## V2500-A1/A5/D5 SERIES PROPULSION SYSTEM NON-MODIFICATION SERVICE BULLETIN

This document transmits the Revision 2 of Non-Modification Service Bulletin V2500-ENG-72-0601.

# V2500-ENG-72-0601

NON-MODIFICATION SERVICE BULLETIN – ENGINE – HIGH PRESSURE (HP) COMPRESSOR – STAGE 3  
TO 8 COMPRESSOR DRUM – OVERHAUL SHOP SPECIAL CLEANING PROCEDURE

NMSB V2500-ENG-72-0601 Accomplishment Flow Chart  
Figure 1

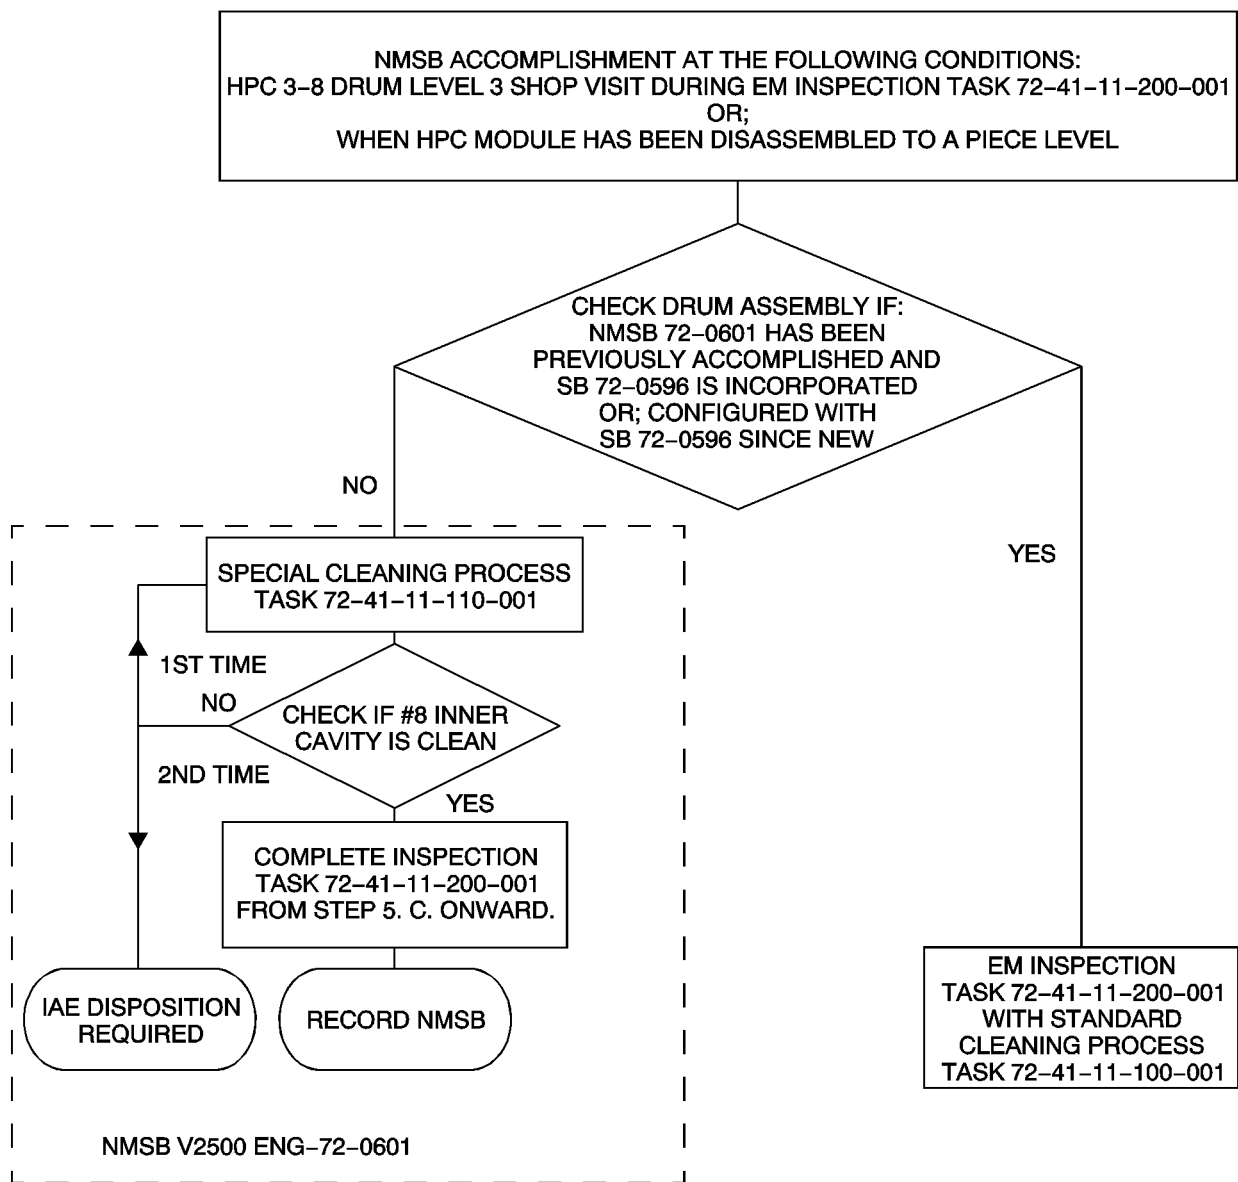
- A. At the next level 3 shop visit of the HP compressor stage 3-8 drum, check engine records if this NMSB V2500-ENG-72-0601 has been previously accomplished, see Figure 1 NMSB accomplishment flow chart.

- B. If NMSB V2500-ENG-72-0601 has been previously accomplished and SB 72-0596 was incorporated, or a new stage 3-8 drum was installed and SB 72-0596 was incorporated:

- (1) Proceed with examination of the HP compressor stage 3-8 drum as per EM inspection TASK 72-41-11-200-001.
- C. If the conditions of paragraph 3.B. are not met:

- (1) Replace cleaning task in EM inspection TASK 72-41-11-200-001, paragraph 5.A.:
- Instruction to be replaced - Clean part. Refer to TASK 72-41-11-100-001.

- Replace with new instruction - Clean part. TASK 72-41-11-110-001.
- (2) Visually inspect stage 8 HP compressor disc inner cavity at inspection location 10 refer to EM inspection TASK 72-41-11-200-001.
